M049.0

Coca-Cola Marketing Machine Door Coin Chute Enhancement

December 20, 2002

Models Affected: Coca-Cola Marketing Machines in Mexico

Figure 1

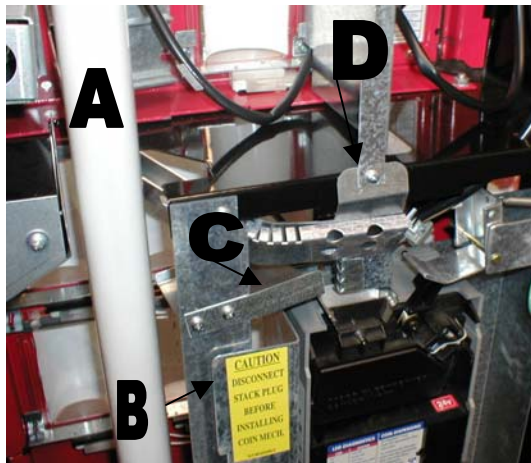
Reason: To provide a Coin Chute that enhances the handling of large coins in the Mexico.

1. Unplug the vender.
2. Remove the Lamp near the existing Coin Chute Assy. See "A" Figure 1.
3. Open the access door. See "B" Figure 1.
4. Remove the water deflector. See "C" Figure 1.

5. Remove the screw securing the existing Coin Chute to the horizontal bulkhead. See "D" Figure 1.
6. Remove the two (2) keps nuts securing the existing Coin Chute Assy. to the back of the Coin Insert. See "E" Figure 2.

Figure 2

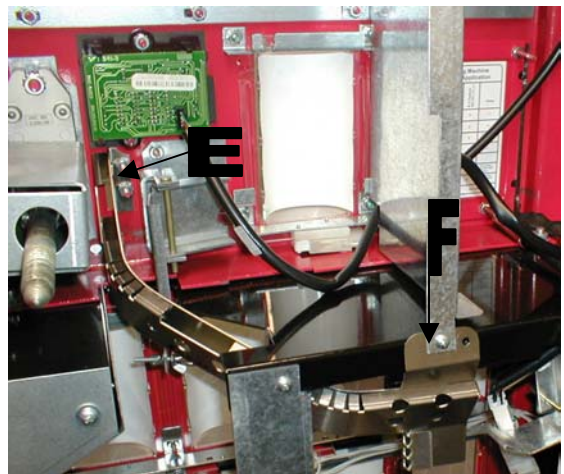
7. Remove and discard existing Coin Chute Assy.
8. Place new Coin Chute Assy. in position. Note: the Coin Chute Assy. should go under the horizontal bulkhead. See Figure 2.

9. Secure Coin Chute Assy. to the Coin Insert with the two (2) keps nuts removed in step 6. See "E" Figure 2.
10. Install the first screw as shown in "F" Figure 2.

11. Check the Coin Chute Assy. alignment with the changer, then install the second screw to secure. See Figure 2.
12. Install the water deflector removed in step 4.

Figure 3

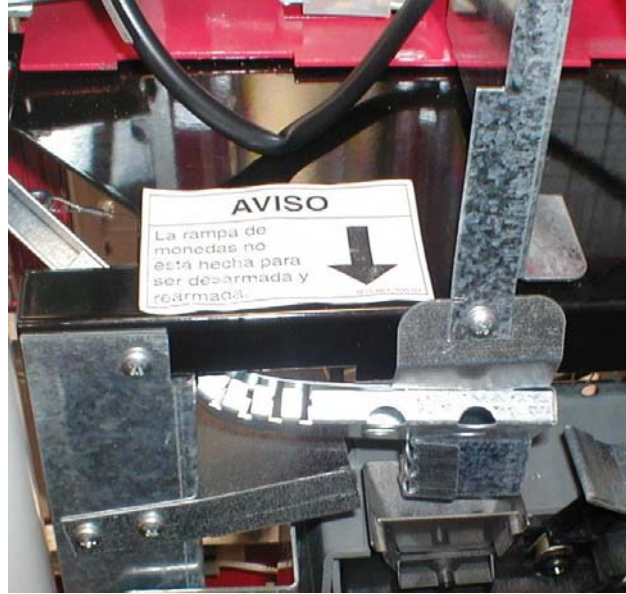
13. Install the Notice Label on the horizontal bulkhead as shown in figure 3.
14. Test coins for proper alignment of chute to coin mechanism.
